## APPLICATION FOR PERMIT TO DRILL, DEEPEN, OR PLUG BACK

**SUNDRY NOTICES AND REPORTS ON WELLS**

Changes to Form 9-331C Dated 7/10/79

NEWSOM "B" NO. 14-E  
1700'/South line & 1765'/East line  
Sec. 9, T-26N, R-8W

**NEW MEXICO OIL CONSERVATION COMMISSION  
WELL LOCATION AND ACREAGE DEDICATION PLAT**

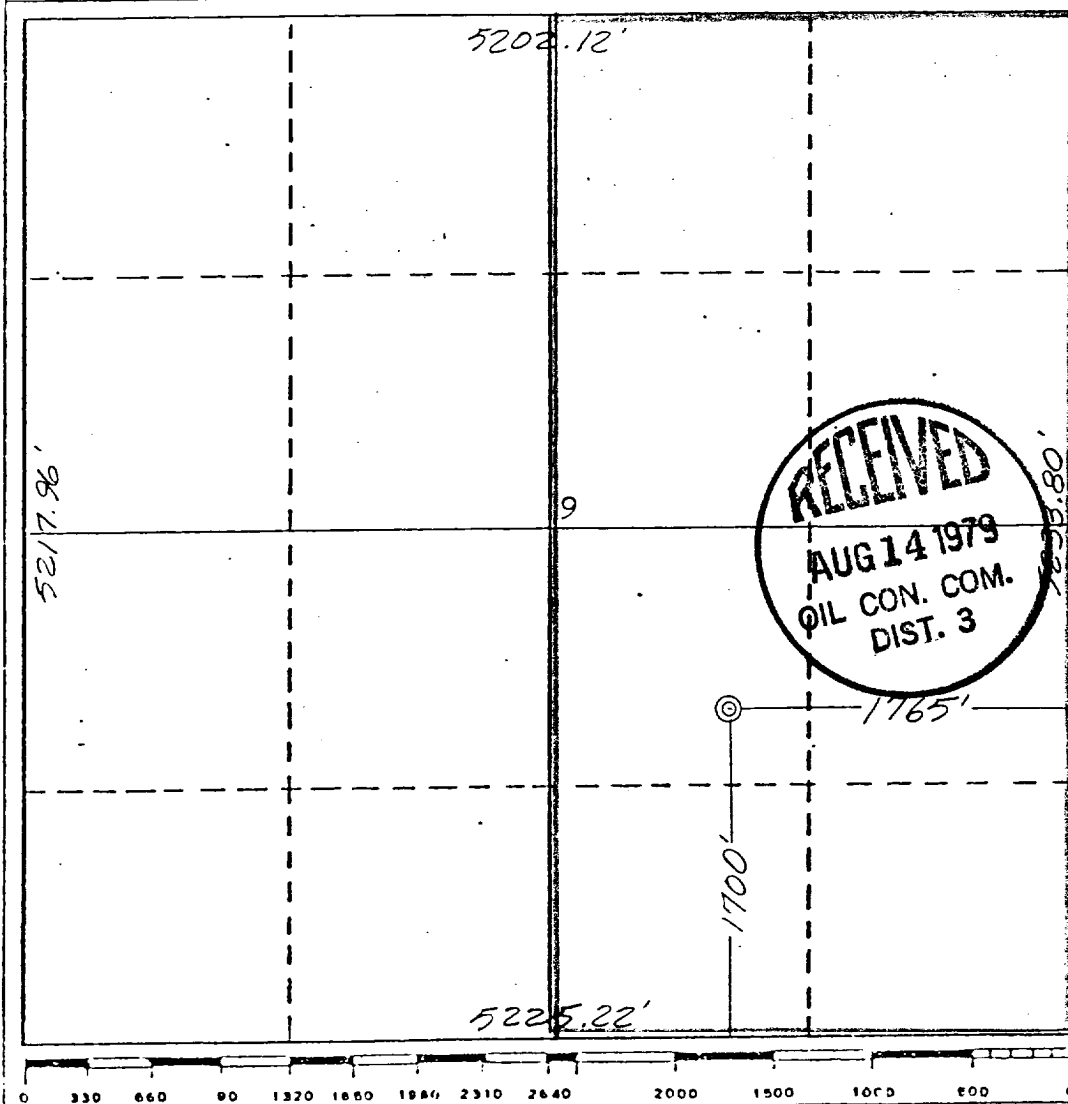
This location was originally staked 1140 ft. from the South line and 1125 ft. from the East line of Sec. 9, Twp. 26N, Rge. 8W. It was moved to 1700 ft. from the South line and 1765 ft. from the East line. The change was necessary because of the inaccessibility of the original location. Also, the B.L.M. representative felt the move would provide more protection for wild life in the area.
